SERVICE BULLETIN

M1330

M1330: 2006-2009 6-SPEED TRANSMISSION REPLACEMENT PARTS

Figure 1. Digital Technician II

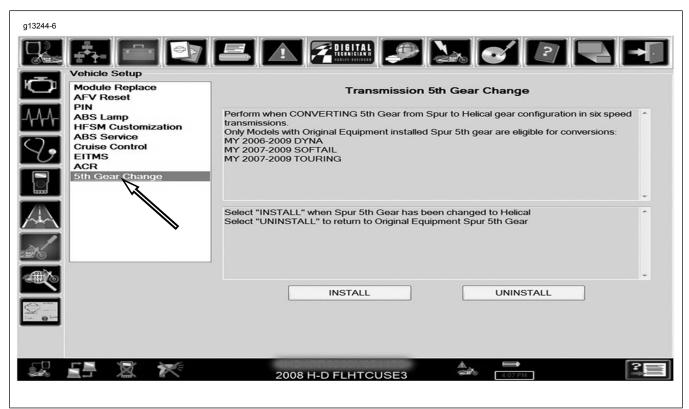
See Figure 1. In Digital Technician II, open Toolbox > Vehicle Setup > 5th Gear Change. Follow the screen prompts to configure the vehicle.

Figure 2. Mainshaft Assembly Kit

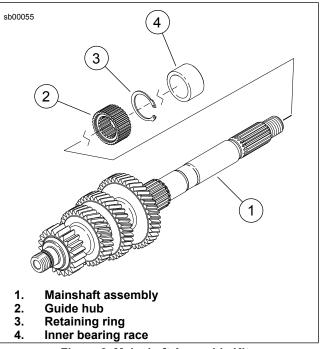
See Figure 2. The mainshaft replacement kit consists of the mainshaft assembly, guide hub, retaining ring and inner bearing race. All parts are model year 2010 or later and replace earlier model mainshafts as a complete kit. Refer to Table 2 for part numbers.

Figure 4. Transmission Case (Touring Shown)

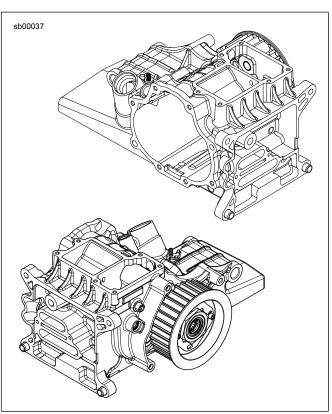
See Figure 4. The replacement case is provided with all bearings, the final drive gear, the pulley, nut and lockplate installed. Refer to Table 4 for part numbers.

Case replacement will require that the following parts be removed and reused:
